City of West Linn
PRE-APPLICATION CONFERENCE MEETING
Notes
April 17, 2014

SUBJECT: Class II Parks Design Review, Willamette River Greenway Permit, Water Resources Area Permit, Flood Management Area Permit, and possible Class II Variances for stream setback and from hardship provisions, for proposed “replica” boat barn at Maddax Woods Park, 5785 River Street

Map of proposed barn area in relation to piped drainageway, overlays. Willamette River River is at top. Light blue lines are open drainageways, including Maddax Creek in the center area of the photo.

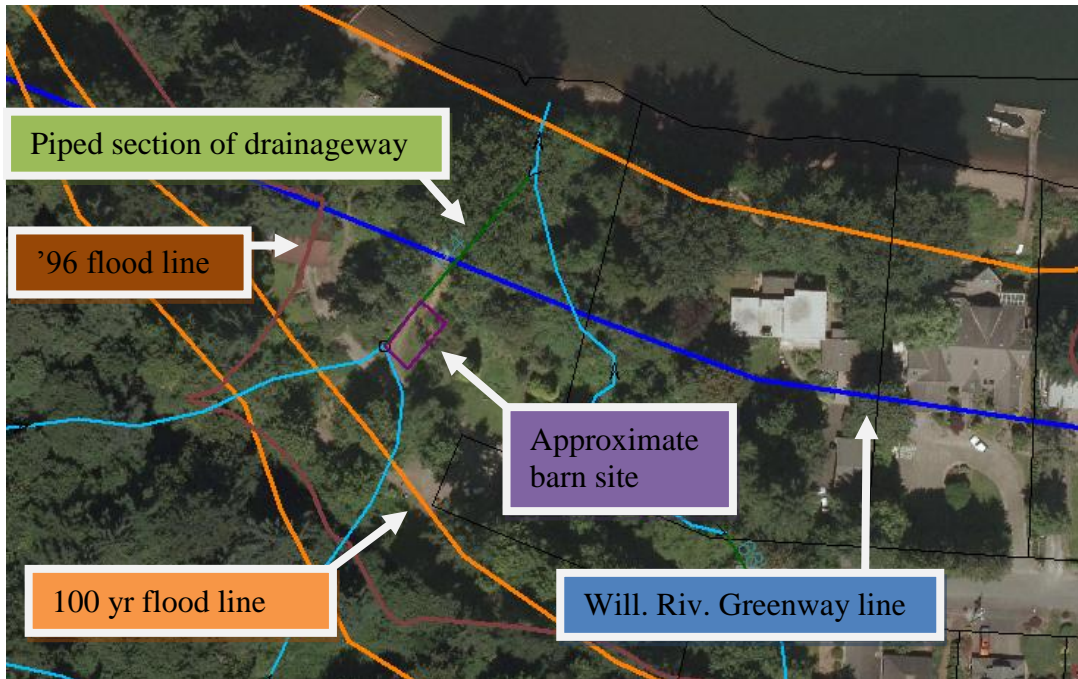
Also, the edge of the foundation is right at the underground pipe where the stream to the west and its nearby tributary have been undergrounded, starting at the house's driveway just south of the barn site. Section 32.050(N) requires that as part of a Class II Design Review, piped drainageways must be opened and their 32.050(E) setbacks respected unless the City Engineer determines that the opening of the drainageway would have a negative effect on water quality and the storm water system. The absolute minimum setback allowed is 15 feet per 32.090(C)(1) even with a Water

Resources Area permit and mitigation. This may make this proposal difficult in terms of compliance with Chapter 32 unless it is determined the drainageway should not be opened, or unless opening it could result in a different trajectory through this part of the site. If the barn is proposed at this location with the creek right beside it, a variance to the minimum structural setback of 15 feet would be necessary. This would be a Class II Variance. To be approved it must meet all variance criteria of Chapter 75 as well as showing that such a proposal can be made to not be environmentally damaging.

If it is determined the stream is able to be daylighted here without harming the system, the applicant shall daylight it as part of a Class II Design Review approval. Engineering's initial look at the site did not produce compelling reasons to leave the stream piped, so it may not be very likely that the division would determine otherwise when the application is under review. To be able to avoid daylighting it under this scenario, a different Class II Variance would be necessary.

Alternately the barn could be built at a somewhat different location on this part of the site so it is further than 15 feet from where the drainageway may be daylighted, avoiding the need to apply for either of the variances discussed above.

Another alternative is to daylight the stream but divert the water around the barn site in a way that allows for a minimum 15-foot setback between water and barn. In this scenario the stream, which already enters Maddax Creek just downstream, could be diverted south of the site to enter Maddax Creek at a slightly different point. The feasibility of this solution would depend on how much Parks can spend or is willing to spend on this engineering project, and whether the solution would be environmentally damaging.

Any daylighted section of this stream will have a standard 50-foot transition area, the same as the other open areas of the same streams nearby (except for the 100-foot transition area for significant riparian corridor Maddax Creek). Therefore mitigation for development would be based on the barn's and associated development's overlap with the transition area, including for areas of the stream daylighted as part of this project. If the proposal includes benches on or terracing of the hillside west of the foundation so visitors can see work being done inside the barn, the square footage of these changes to the environment would also have to be mitigated for.
